Lincolnshire County Council

LOCAL IMPACT REPORT

Gate Burton Solar Park

FIGURE NUMBER
Figure 1-3b

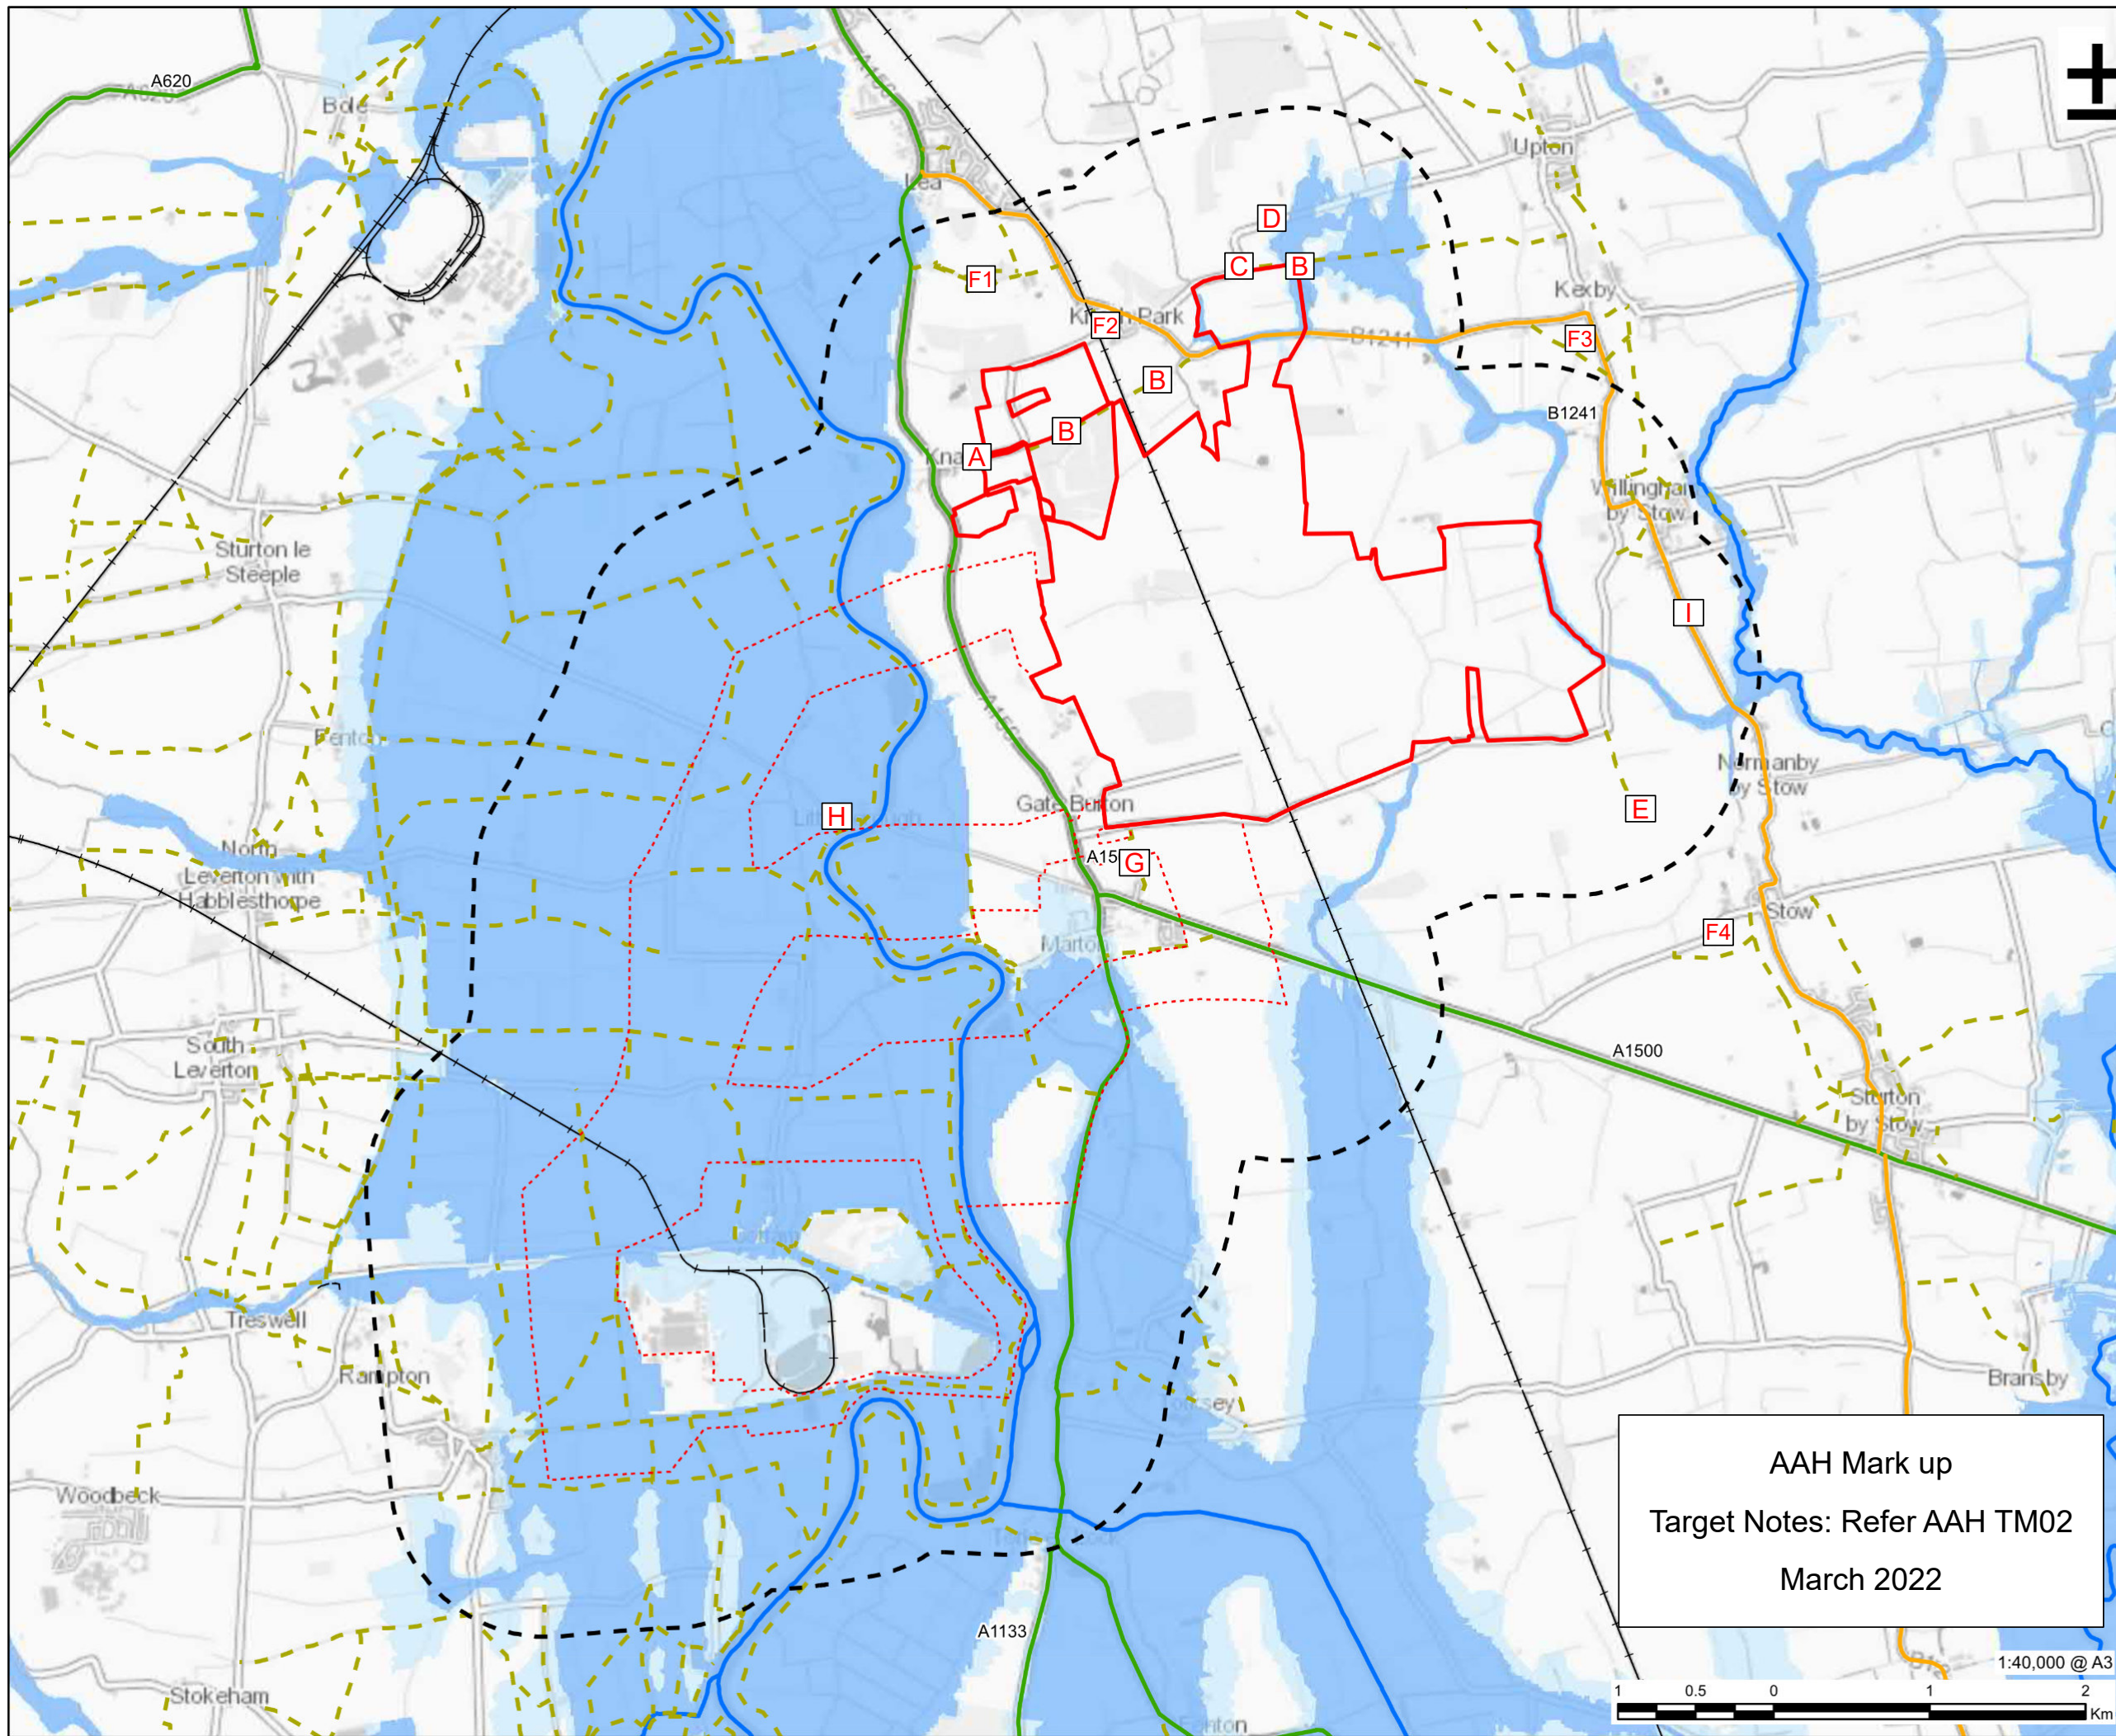
- H. Could a clear statement provided as to potential views from Littleborough and them being reviewed and subsequently scoped out. There are several heritage assets as well as PROW in this location and it is not clear if this location has been fully reviewed in regards to views of the site and development – if there are potential views of the site and/or proposed development, a viewpoint should be obtained from this location; and
- I. Could a clear statement be provided as to potential views from the B1241 between Willingham by Stow and Normanby by Stow and them being reviewed and subsequently scoped out. The B1241 is referenced within para. 10.4.16 of the scoping report as having views of the site.

As stated, at this stage we do not have details on the location and appearance/extent of taller/larger elements that for part of the development which would likely have visual impacts that would require additional viewpoints beyond those initially identified.
